## PRODUCT/PROCESS CHANGE NOTICE (PCN)

PCN #: <b>A-0310-01</b>	DATE: 10/10/2003	MEANS OF DISTINGUISHING CHANGED DEVICES:	
Product Affected: <b>Not Applicable (New Product Offering)</b>		<input checked="" type="checkbox"/> Product Mark	"G" character in the package code (New ordering Part # for Green Parts)
Date Effective: 10/10/2003		<input type="checkbox"/> Back Mark	
		<input type="checkbox"/> Date Code	
		<input type="checkbox"/> Other

### ATTACHMENT - PCN #: A-0310-01

**PCN Type:** Green product offering

# IDT 260°C Reflow Profile

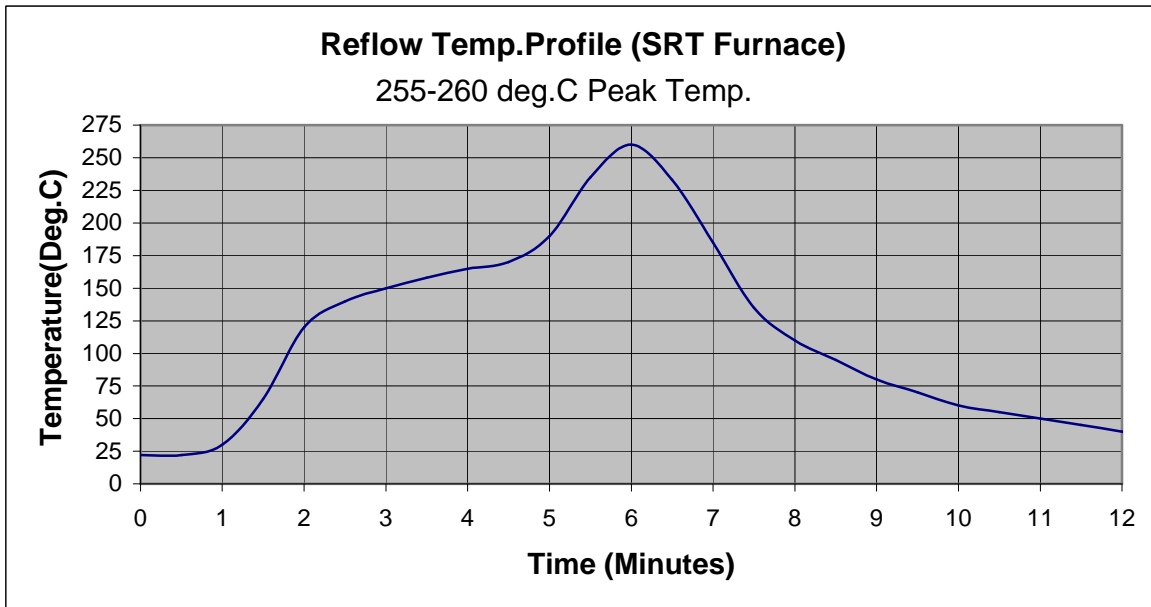
Green Parts are assembled using material sets that are selected for their superior properties and low moisture absorption. Green parts are qualified using JEDEC-Std-020B for moisture sensitivity classification with peak reflow temperature of 260°C. Please see below the recommended 260°C reflow profile. Reliability tests include Auto Clave, HAST, Temperature Cycle, Solderability, Storage tests, and tin whisker inspection.

Parameter	Value
Max. Ramp-up Rate (200°C to Peak)	3°C/second
Preheat Time (175°C ± 25°C)	60-180 seconds
Time Maintained Above 217°C	60-150 seconds
Time within 5°C of actual Peak Temp	20-40 seconds
Peak Temperature	255°C +5/-0°C
Max. Ramp-Down Rate	6°C/second
Time 25°C to Peak Temperature	8 minutes max.
